## MEMORANDUM

To: David E. Griffith, PE  
 From: Reneé Whittenberger, PE, RSP1 and Sela Jones, EIT  
 Date: January 30, 2025  
 Subject: Addendum to Report Recommendations

Upon providing a schematic plan of proposed countermeasures in the *TRU-SR 193-1.67 Roadway Segment Safety Improvement Study*, project team members met with stakeholders to gather feedback prior to the request of implementation funding. The following recommendations were provided in the report:

Upon receiving input from members of the Township, the project team has created a revised plan of proposed countermeasures which is to be utilized for the request of implementation funding. These changes are clarified herein:

## OHIO DEPARTMENT OF TRANSPORTATION

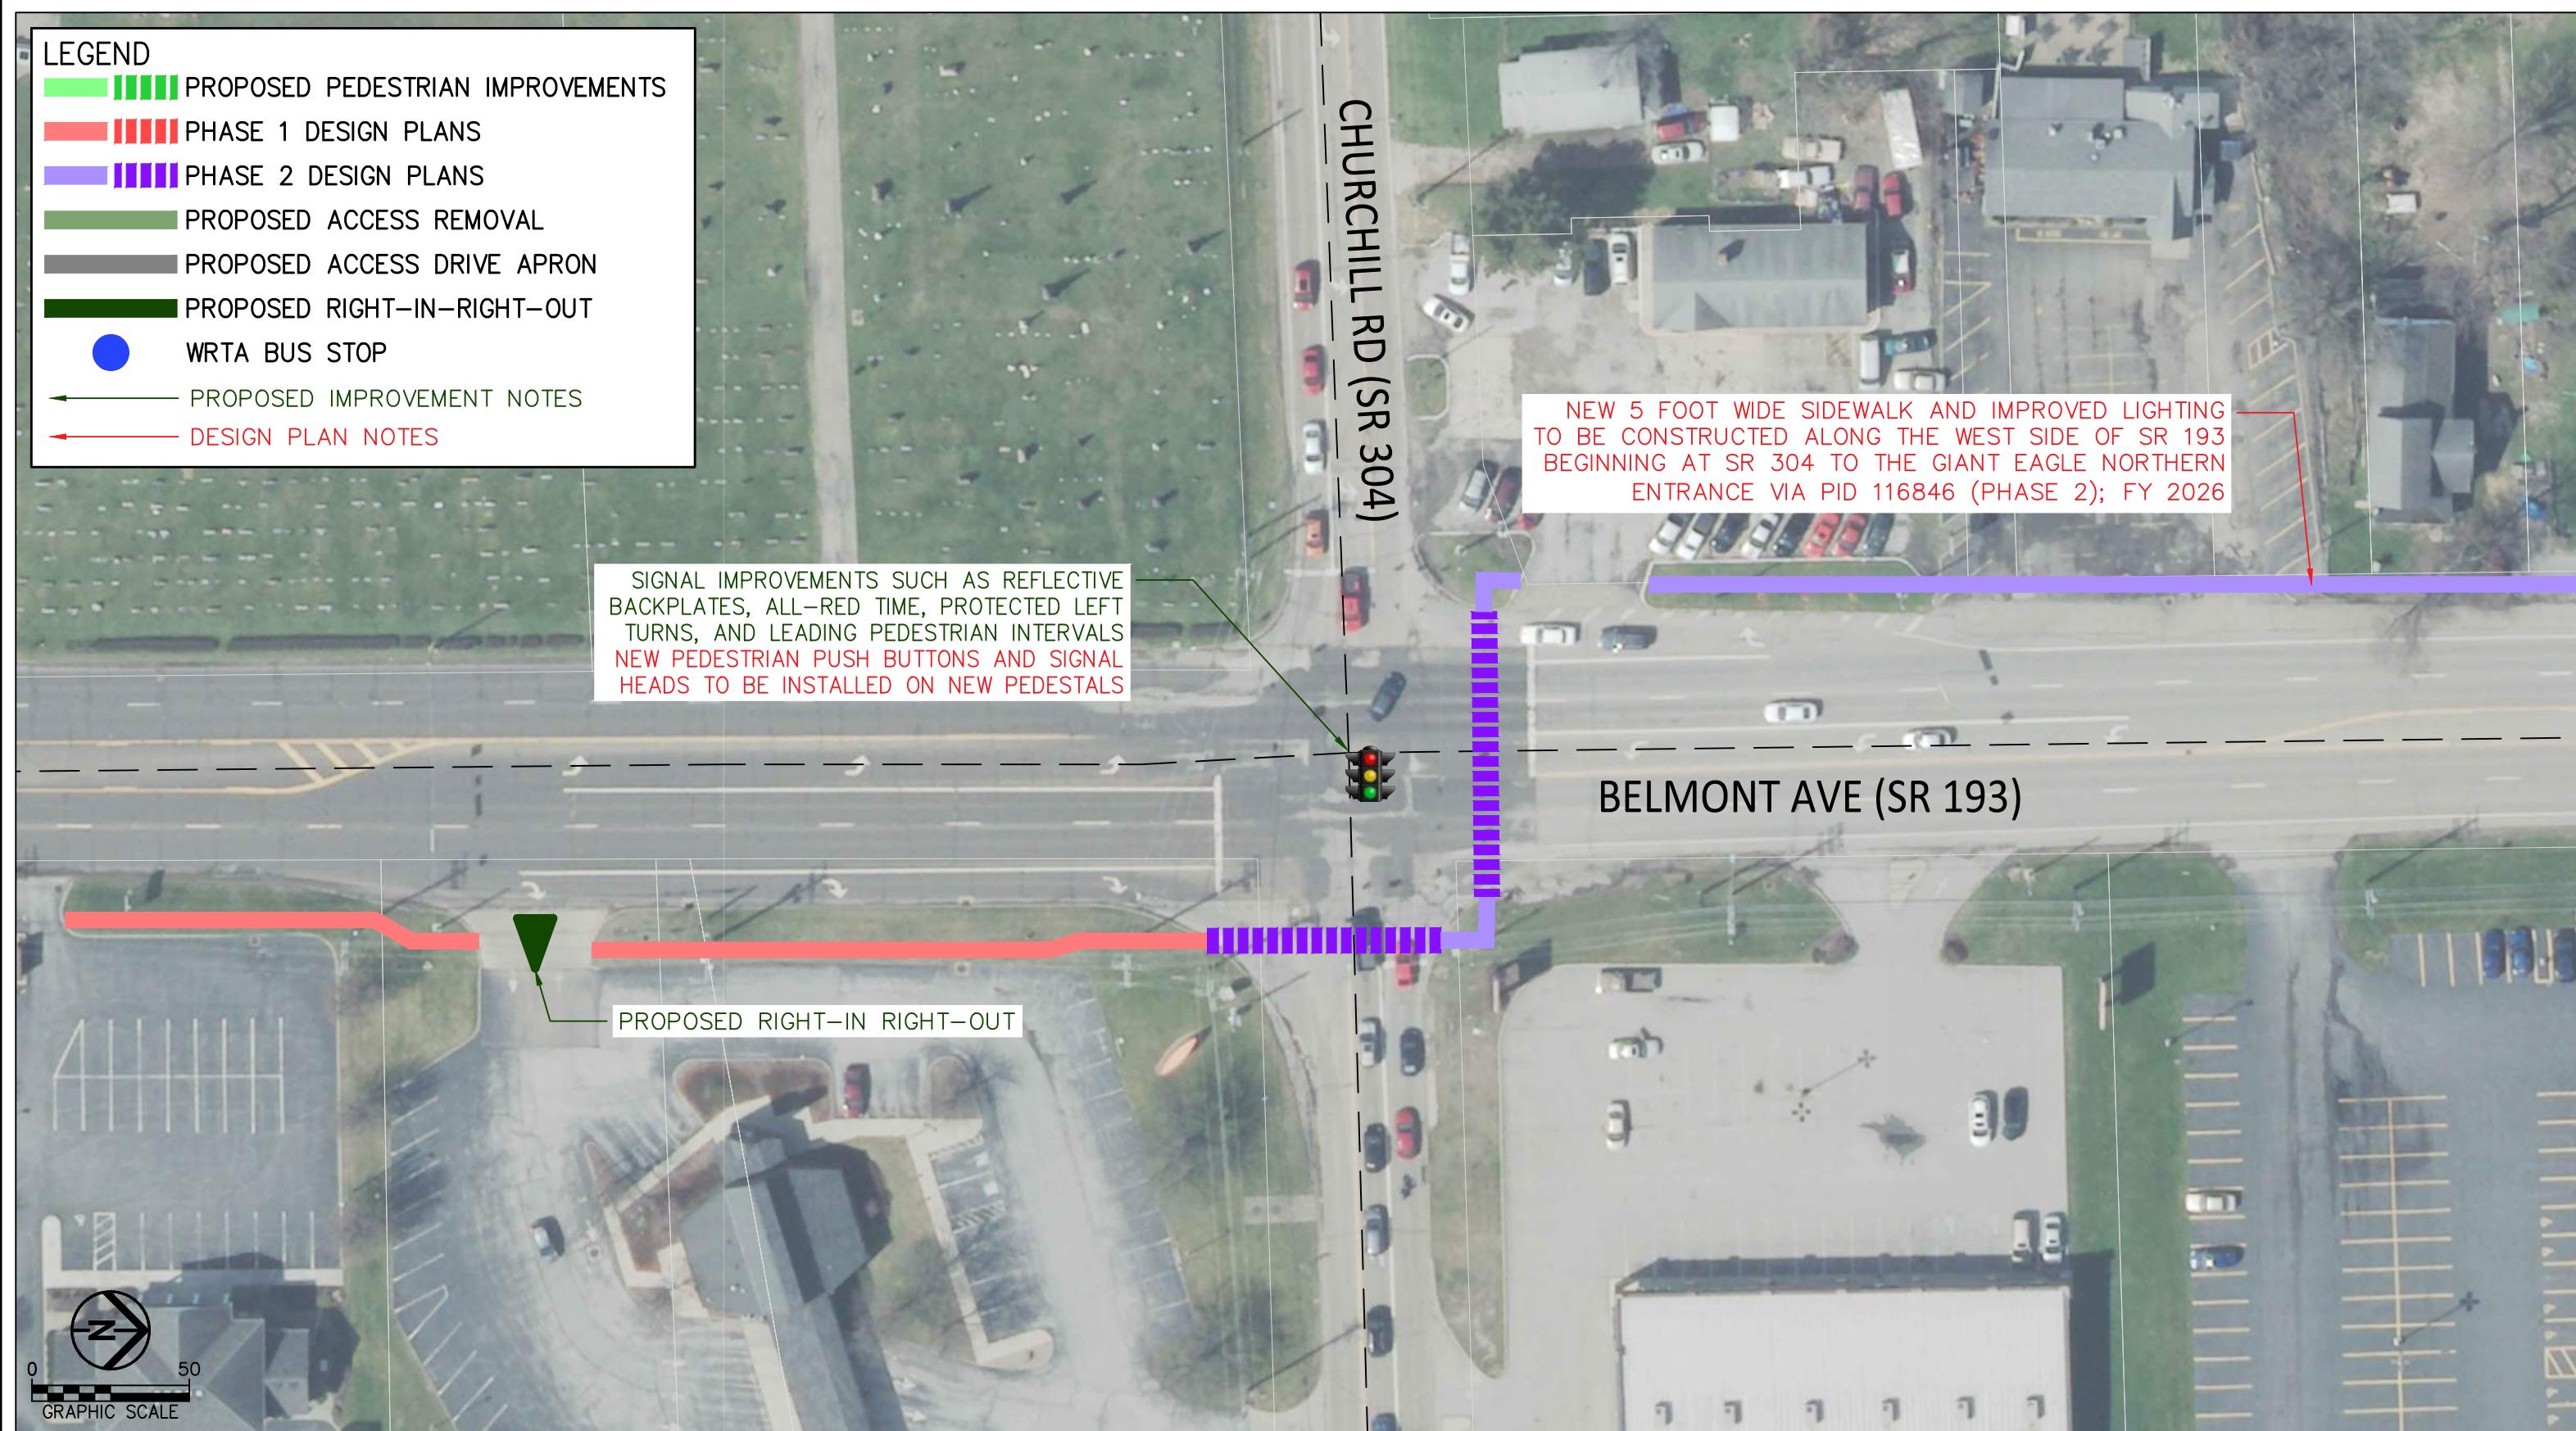
- Members of the Township expressed disinterest in providing sidewalk on the east side of SR 193 in proximity to the I-80 overpass, due to concern that the proposed infrastructure will encourage pedestrian activity near high-speed vehicles preparing to enter I-80. This includes the eastbound ramp south of the overpass and the slip lane which transitions into the westbound ramp north of the overpass. Presently,

the only amenity for pedestrians in this area is the *Belmont Avenue & Motor Inn Drive WRTA* bus stop. Stakeholders discussed their interest in moving this bus stop north of the westbound I-80 ramps in hopes of discouraging pedestrian traffic in the vicinity of high-speed vehicles preparing to enter I-80. This feedback has resulted in the removal of proposed sidewalk, crosswalks, and a rectangular rapid flashing beacon (RRFB) in this area. As a result, **the new sidewalk on the east side of SR 193 is now proposed to begin at Liberty Street and end at the entrance to the Baymont by Windham entrance.**

- Members of the Township expressed disinterest in removing access at the Speedway gas station across from the westbound I-80 ramps, due to the concern that incoming trucks will lose the ability to maneuver into the establishment. Also, the existing access point contains a median which facilitates right-in right-out movements. The project team agrees that this entrance can remain in its existing configuration. As a result, **access removal at the Speedway entrance is no longer proposed.**

- Members of ODOT District 4 expressed concern over the access management proposed for the restaurant property on the west side of SR 193 south of the I-80 overpass. Due to the multiple existing access points at the property, which increase exposure for crossing pedestrians, project team members recommended one shorter access point available at the north end of the lot. However, ODOT District 4 was concerned over the possibility of exiting patrons' ability to cross five lanes of traffic through the gap in the median in hopes of traveling northbound on SR 193 or entering the eastbound I-80 ramp. As a result, **the new access point of the restaurant property south of the I-80 overpass is now recommended for the south end of the lot, as this configuration utilizes the existing median to limit movements to right-in right-out only.**

- In the interest of maintenance and cost, **replacing the median** between the I-80 overpass and the I-80 westbound ramp intersection **was not preferred. The existing median will remain.**
